#### Electric Power Generation, Transmission, and Distribution; Electrical Protective Equipment; Corrections

**ACTION:** Correcting amendments.

**SUMMARY:** On April 11, 2014 (79 FR 20316), the Occupational Safety and Health Administration published a final rule: Revising the general industry standards for electric power generation, transmission, and distribution work and for electrical protective equipment; revising the construction standard for electric power transmission and distribution work; and adopting a new construction standard for electrical protective equipment. The final rule updated those standards and made the general industry and construction standards consistent. This document corrects errors in the preamble and regulatory text of the final rule.

Table R–3—AC Live-Line Work Minimum Approach Distance

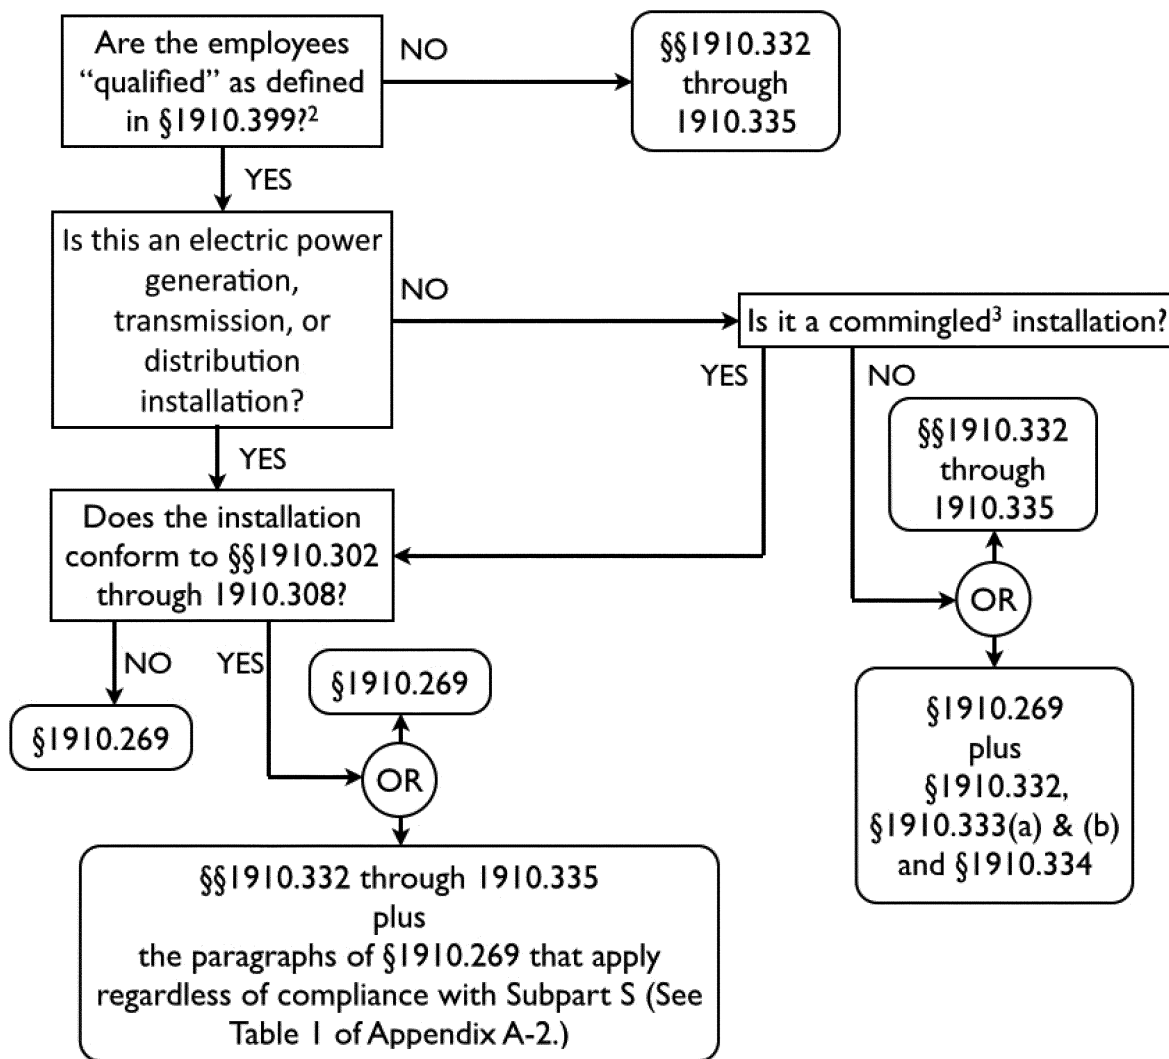
■ i. Under the entry “For phase-to-phase system voltages of more than 72.5 kV, nominal”, in the thirteenth row, revise the equation;

MAD = 0.3048(C + a)V<sub>L-G</sub>TA + M
